SUTTON CONSERVATION COMMISSION

MINUTES

Re: **Construction Phase - Site Modifications**
172 Manchaug Road, Sutton, MA (Map 42 Lot 13) - *Location*
Karen & Michael Bronson - *Owner*

LOCAL UPGRADE SITE DEVELOPMENT & FACILITIES PLAN

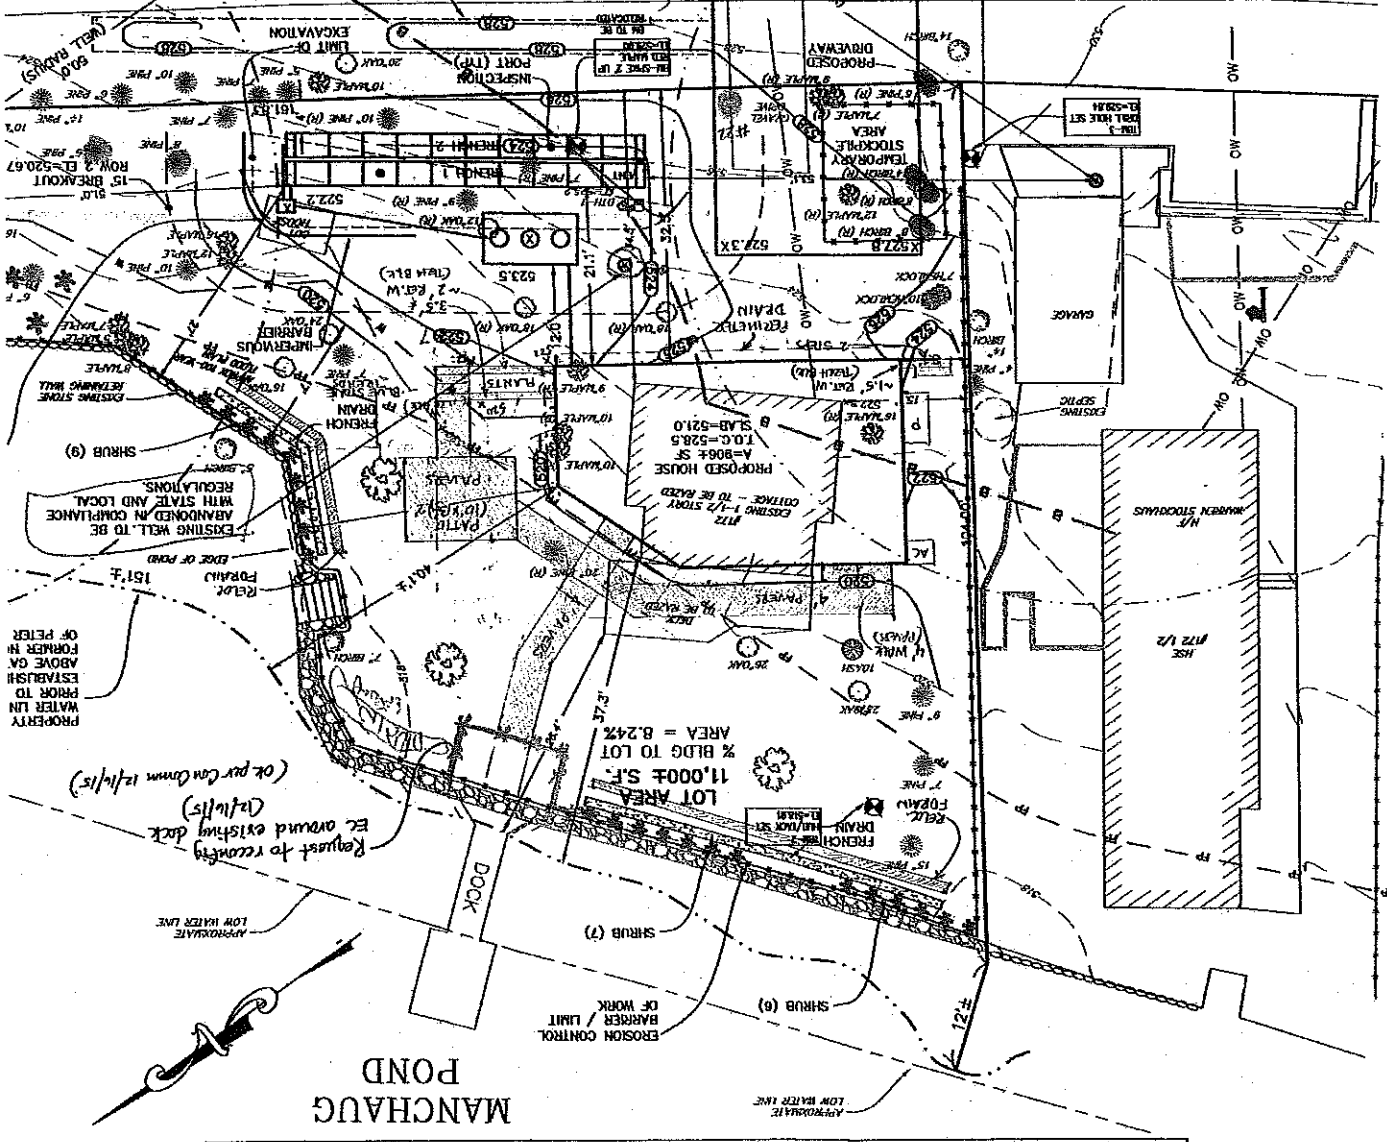
1. Reduce the steeper slopes and potential erosion at the front corners of the house by constructing a small landscaped retaining wall on each side of the front house corners using a block wall type product (12" x 6" blocks) for the landscaping walls and blue stone treads for the steps. The west side would be approximately a 1.5' high wall to accommodate 1 to 2 steps down to the side yard. The east wall would be approximately 2' to 3.5' in height to accommodate 6± steps down to the side yard. This would moderately flatten the grades behind and in front of the wall and prevent washout at the corners. Essentially there would be no impacts to the currently designed runoff or septic system, just protection of the slopes at the house corners.

2. Provide 4' wide walks using pavers from the front yard to the back door and to boat ramp area, as well as a 10' x 13' patio area also constructed with pavers.

3. Move the proposed French Drains (that are approximately 2' from the back of the walls) to approximately 1' to 2' inland to allow for more planting space and to keep construction of French Drains away from existing wall.

No existing trees will be impacted by these modifications. See sketch dated 11/1/16. Please note that the building inspector required a foundation drain that has been installed. Please contact us at our Whitinsville office at (508) 234-6834 if you have any questions.

11/1/16 REV. W/ 10' DPTD W/ BUBBLES IN RUSK ROAD; RELOCATE F-DRAIN W/ LAND. KG
